# UNITED STATES PATENT AND TRADEMARK OFFICE

APPLICATION NO.	FILING DATE	FIRST NAMED INVENTOR	ATTORNEY DOCKET NO.	CONFIRMATION NO.
10/041,599	01/10/2002	Nick Chen	CHEN-336	5101
1444	7590	06/02/2004	EXAMINER	
BROWDY AND NEIMARK, P.L.L.C. 624 NINTH STREET, NW SUITE 300 WASHINGTON, DC 20001-5303			HAMILTON, ISAAC N	
			ART UNIT	PAPER NUMBER
			3724

<b>Office Action Summary</b>	<b>Application No.</b> 10/041,599	<b>Applicant(s)</b> CHEN, NICK	
	<b>Examiner</b> Isaac N Hamilton	<b>Art Unit</b> 3724

**DETAILED ACTION**

Diagram 1: Figure 1 in Huang-Mo.

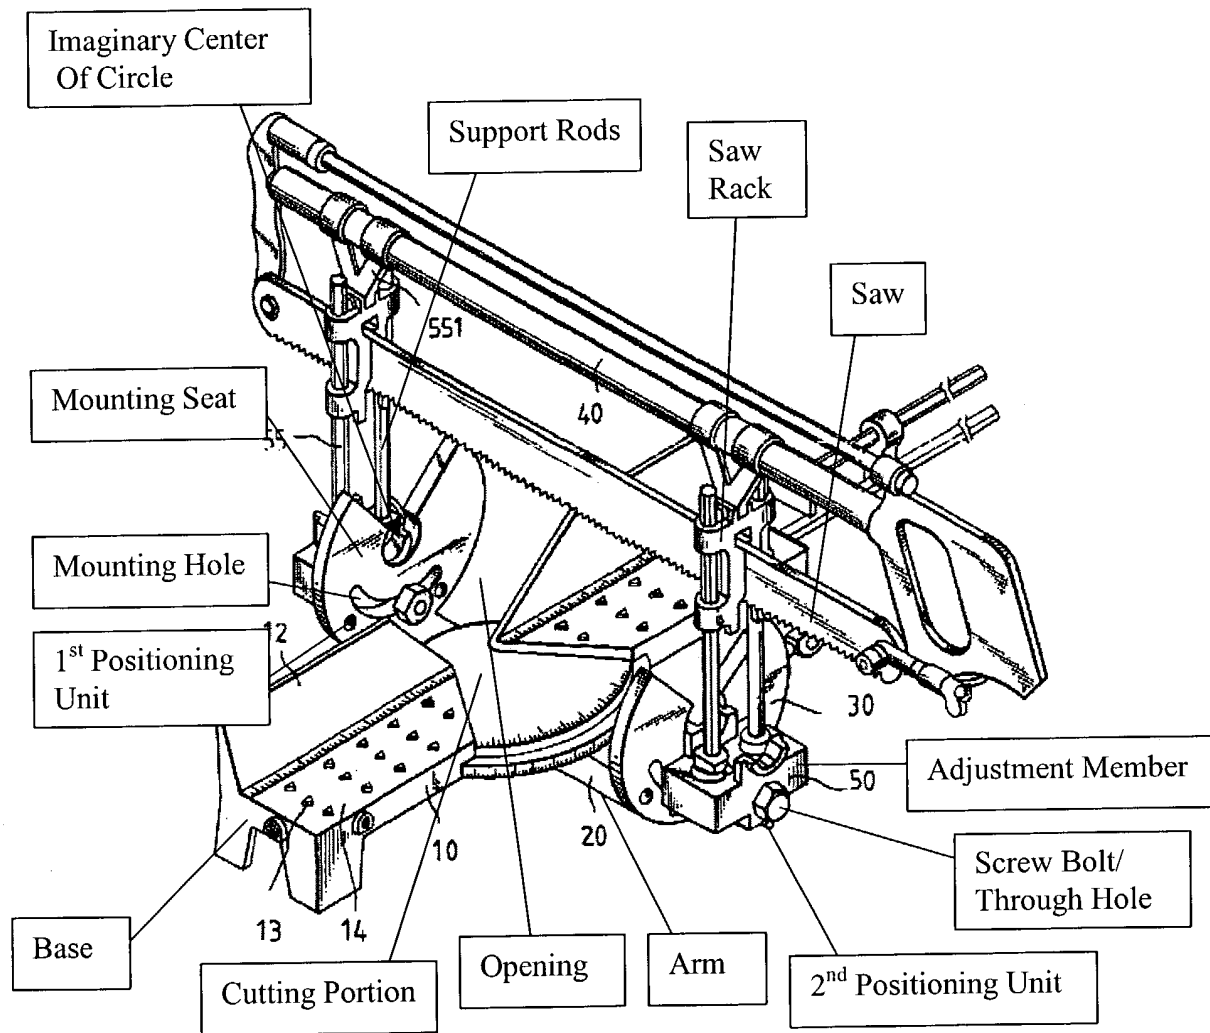
2. Claim 1 is rejected under 35 U.S.C. 102(b) as being anticipated by Huang-Mo et al (5,605,086), hereafter Huang-Mo. Huang-Mo discloses everything as noted below in Diagram 1 except for free rotation of the suspension arm, which is disclosed in column 2, line 5. Retaining portion and coupling portion are inherent due to column 2, lines 10-15, which disclose that arm 20 is releasably secured in place. See diagram below:

4. Claims 2-5 are rejected under 35 U.S.C. 103(a) as being unpatentable over Huang-Mo in view of Wang (5,392,679). Huang-Mo discloses everything as noted above, but does not disclose slots and does not disclose a locating rib. However, Huang-Mo teaches slots 33 and locating rib 43. It would have been obvious to provide slots and a locating rib in Huang-Mo as taught by Wang in order to provide a greater surface area between the first and second positioning units, which increases stability. Regarding claims 4 and 5, the mounting hole in Huang-Mo is arched. Note that the imaginary center of circle of the mounting hole and slots is labeled in Diagram 1.
